Carisbrook Flood Study Review

Department of Environment, Land, Water and Planning

V2 | Final

February 27, 2018

Figure 4.1 : Tullaroop (Deep) Creek immediately downstream of the Pyrenees Highway 23/11/2017

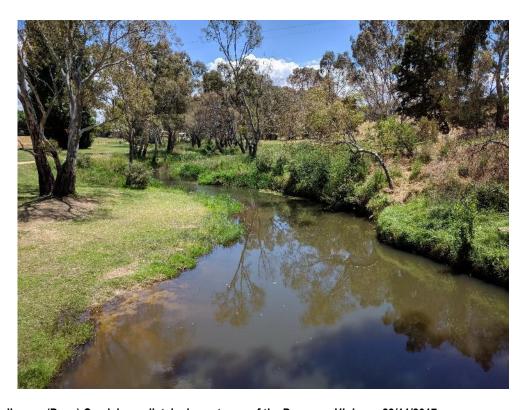
The channel clearing was completed at the time of the site inspection on the 23rd November 2017. This is demonstrated in Figure 4.1 although the extent is different to that in the adopted flood mitigation plan. The effectiveness of the different extents for channel clearing was tested by Water Technology (2016) who concluded that the vegetation cleared by the NCCMA on behalf of Central Goldfields Shire provided the same level of protection to the Carisbrook community.
